Application No.	Applicant(s)
Office Action Summary	10/790,128	TOMIOKA ET AL.
Office Action Summary	Examiner	Art Unit
The MAIL ING DATE And	Tarifur R Chowdhury	.2871
The MAILING DATE of this communication app Period for Reply	ears on the cover sheet with the	correspondence address
A SHORTENED STATUTORY PERIOD FOR REPLY THE MAILING DATE OF THIS COMMUNICATION. - Extensions of time may be available under the provisions of 37 CFR 1.13 after SIX (6) MONTHS from the mailing date of this communication. - If the period for reply specified above is less than thirty (30) days, a reply If NO period for reply is specified above, the maximum statutory period w - Failure to reply within the set or extended period for reply will, by statute, Any reply received by the Office later than three months after the mailing earned patent term adjustment. See 37 CFR 1.704(b).	36(a). In no event, however, may a reply be within the statutory minimum of thirty (30) drill apply and will expire SIX (6) MONTHS fro	timely filed ays will be considered timely. m the mailing date of this communication.

DETAILED ACTION

- 5. Claim 1 is rejected under 35 U.S.C. 103(a) as being unpatentable over Matsumoto et al., (Mats

FIG. 8

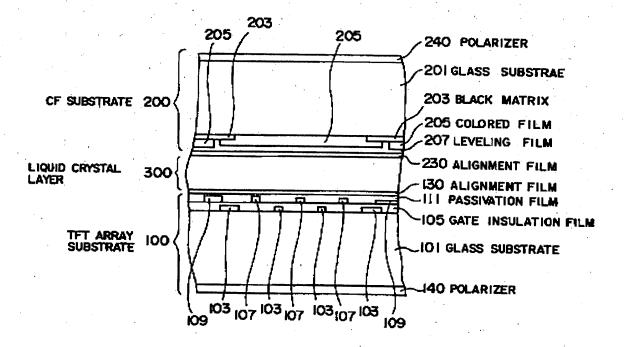
alignment layers (130, 230) is formed on a surface in contact with the liquid crystal layer of each of the pair of substrates.

Matsumoto differs from the claimed invention because they do not explicitly disclose that the alignment layer is made of an organic polymer selected from the group consisting of polyamic acid group polymers and polyimide ester group polymers having a relative imidization ratio of above 60%.

Sunohara discloses a liquid crystal display including alignment layers wherein the alignment layers are made of organic polymer selected from the group consisting of polyamic acid group polymers and polyimide ester group polymers having a relative imidization ratio above 90% (abstract) (which is above 60%). Sunohara also discloses that such alignment layers provide a display that is free from fault in display performance (col. 2, lines 33-35).

Sunohara is evidence that ordinary workers in the art of liquid crystal would find a reason, suggestion or motivation to use alignment layers that is made of an organic polymer selected from the group consisting of polyamic acid group polymers and polyimide ester group polymers having a relative imidization ratio of above 60%.

Therefore, it would have been obvious to one of ordinary skill in the art at the time of the invention was made to modify the display of Matsumoto such that the alignment layers are made of an organic polymer selected from the group consisting of polyamic acid group polymers and polyimide ester group polymers having a relative imidization ratio of above 70%, so that a display that is free from fault in display performance is obtained.

Accordingly, claim 1 would have been obvious.
